The Corporation of the City of Kawartha Lakes
Committee of Adjustment Report – John and Susan Cook
Report Number COA2020-030

Subject: The purpose and effect is to request relief from the following provisions in order to permit an addition to a single detached dwelling and permit an accessory building (shed):

The variances are requested at 152 Island Drive, geographic Township of Somerville (File D20-2020-026).

APPENDIX " D2 "

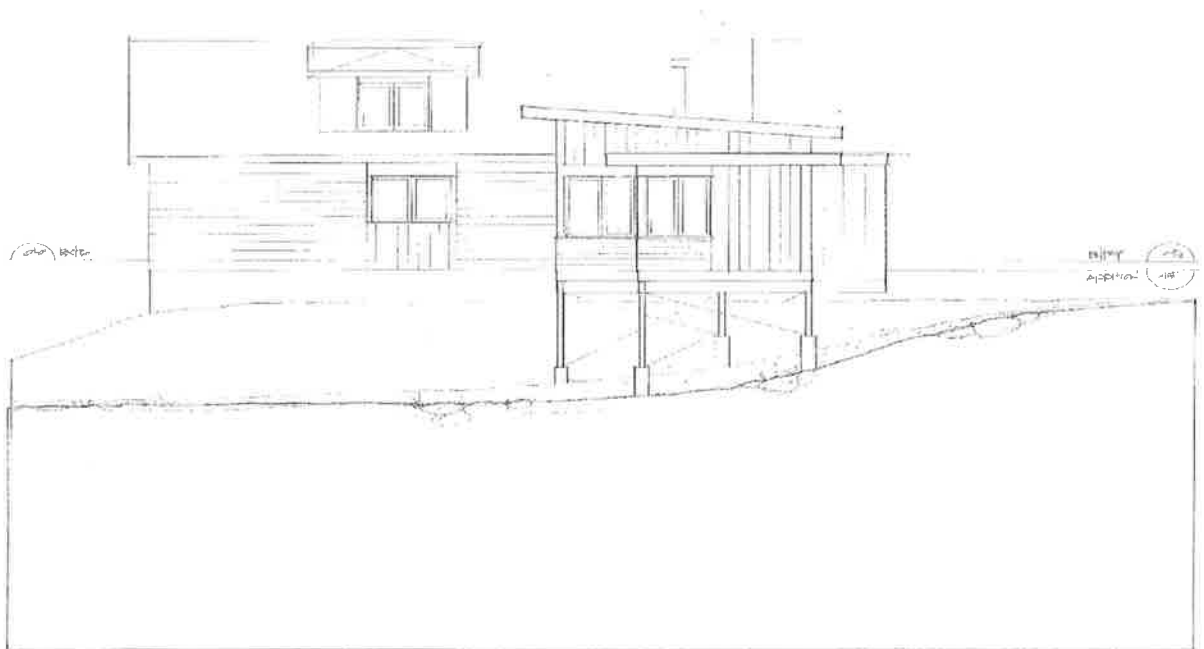
- 2) **That** the west face of the southerly one-storey dwelling addition not extend west beyond the projection line of the east face of the existing dwelling as illustrated on Appendices D2 and E1;
